# Work Order ID 107976

DESIGN <i>[Signature]</i>	DRAWN BY <i>[Signature]</i>	DART AEROSPACE LTD HAWKESBURY, ONTARIO, CANADA	
CHECKED <i>PH</i>	APPROVED <i>[Signature]</i>	DRAWING NO. D3303	REV. B SHEET 1 OF 4
DATE 06.08.17		TITLE HEAD REST SCALE 1:3	
REV	DATE	DESCRIPTION	
A	04.08.18	NEW ISSUE	
B	06.08.17	UPDATED FLAT PATTERN TO FORM PART IN ONE OPERATION USING OFFSET DIE

DRAWING NO. D3303	TITLE HEAD REST	REV. B	DART AEROSPACE LTD ENGINEERING ORDER		D.E.O. NO. D3303-B-1	SHEET NO. SHEET 1 OF 1	SCALE NTS
DRAWN AJS	CHECKED [Signature]	MFG. APPR. [Signature]	APPROVED [Signature]	DE APPR. [Signature]			
DATE 08.10.15	DATE 08.10.15	DATE 08/10/16	DATE 08/10/16	DATE 08/10/16	DATE 08/10/16

### D3303-041 HEAD REST

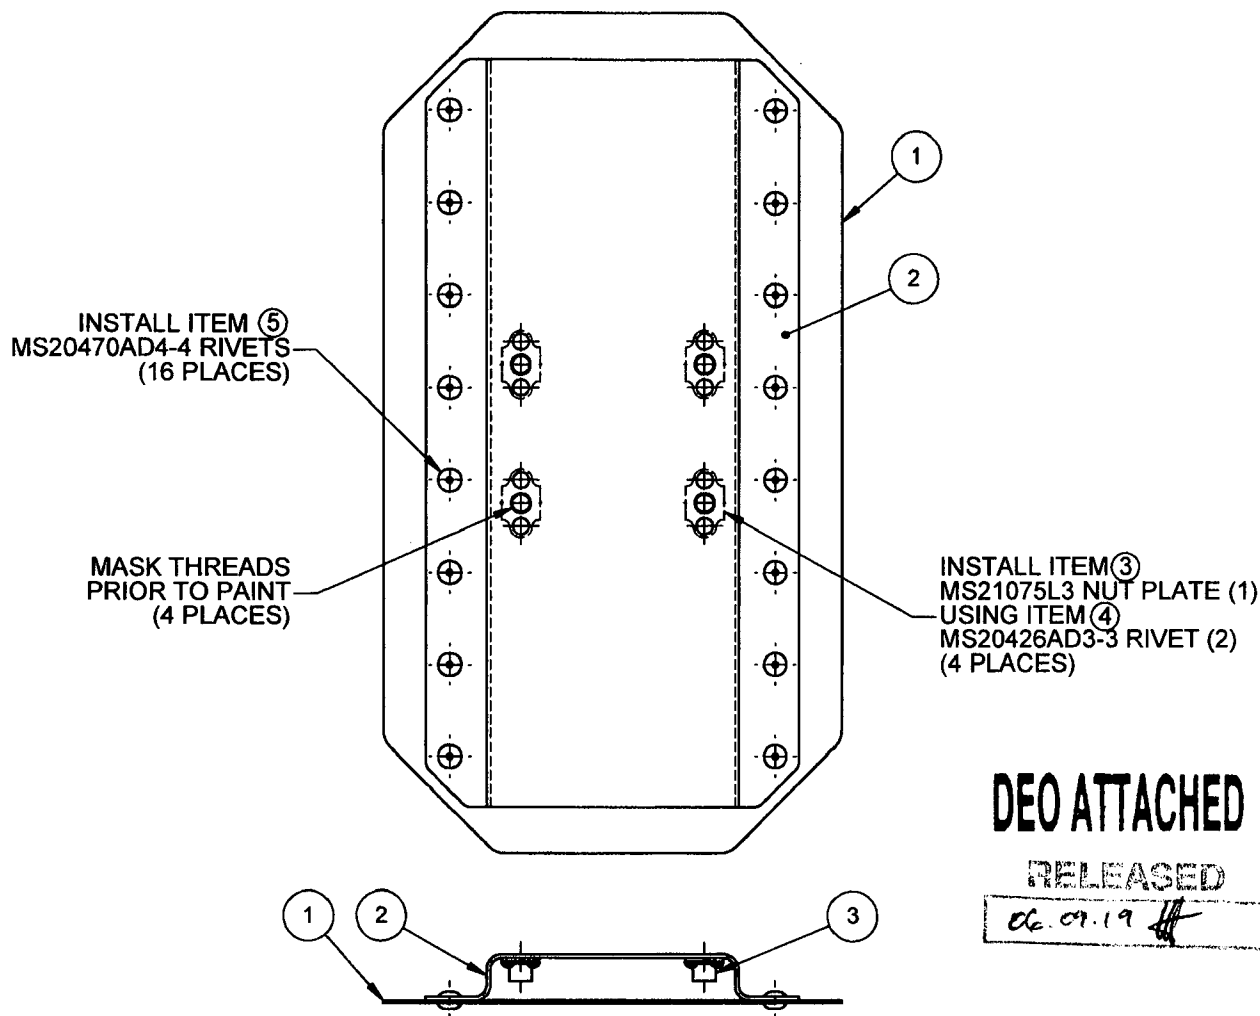
SHEET 1 ADD 1300L ADHESIVE BY 3M TO NOTE 1 AS FOLLOWS:

- 1) BOND D3305-1 FOAM TO D3303-043 BRACKET ASSEMBLY USING 3M 1300 ADHESIVE (0.002" TO 0.010" THICK) IN ACCORDANCE WITH MANUFACTURER'S INSTRUCTIONS

- 1) BOND D3305-1 FOAM TO D3303-043 BRACKET ASSEMBLY USING 3M 1300 OR 1300L ADHESIVE (0.002" TO 0.010" THICK) IN ACCORDANCE WITH MANUFACTURER'S INSTRUCTIONS
